# ETON America, LLC

## Service Bulletin

Bulletin No: 0016  
Date: 10/06/03

### Yukon (YXL-150) Flywheel Nut Coming Loose

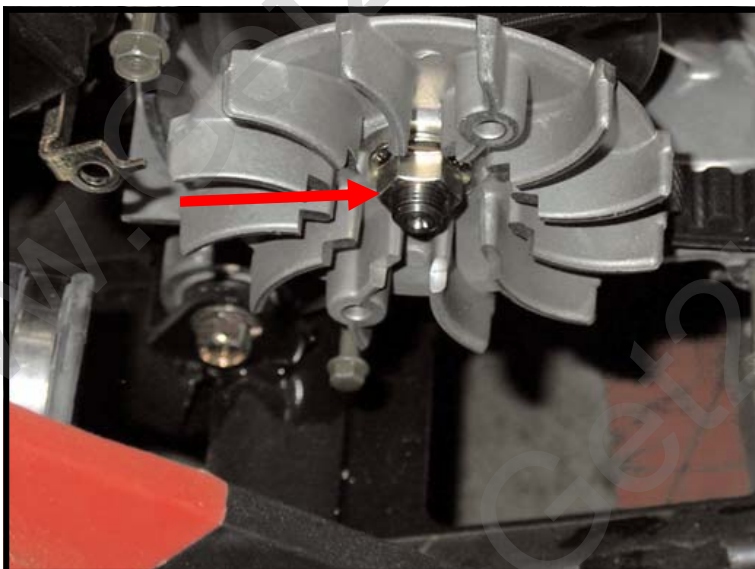
We have found in some cases that the flywheel nut is coming loose and causing severe internal damage, possibly damaging the crankshaft.

Apply locktight to crankshaft threads and torque nut to 85 ft. lbs.

1. Remove left hand CVT cover to gain access to the flywheel assembly.
2. Remove Flywheel nut from crankshaft and **apply Blue locktight** to threads.
3. Re-Install Flywheel nut on crankshaft, torque value **85 ft/lbs**
4. Re-Install CVT Cover.
5. Road test unit to verify correction.
